Request for Class II Permissive Change(C2PC)

FCC ID: RSFEM034AMN

This is a C2PC application for which the previous grant was issued on 2012-03-01.

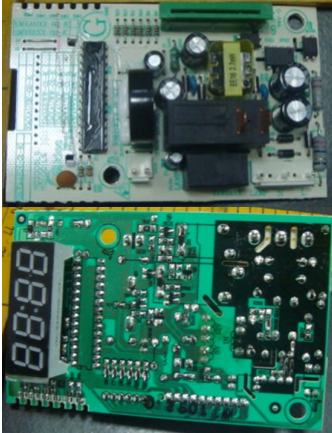
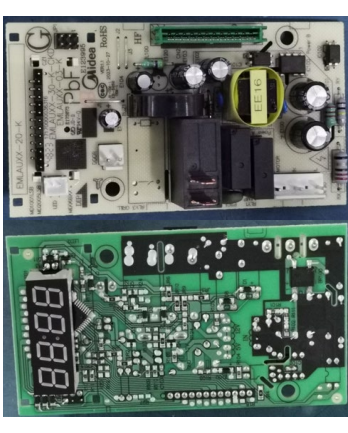
No.:	Original	New	Difference(s)
1			Keypad: Updated front keypad to accommodate child lock function (Child resistant oven door function).
2			Mother board: Modified the peripheral circuit (non-RF circuit) and some individual components and PCB layout. The magnetron and other circuit are exactly same as before.
3	Not Applicable		The new one adds a solenoid valve locking mechanism, the original is not.
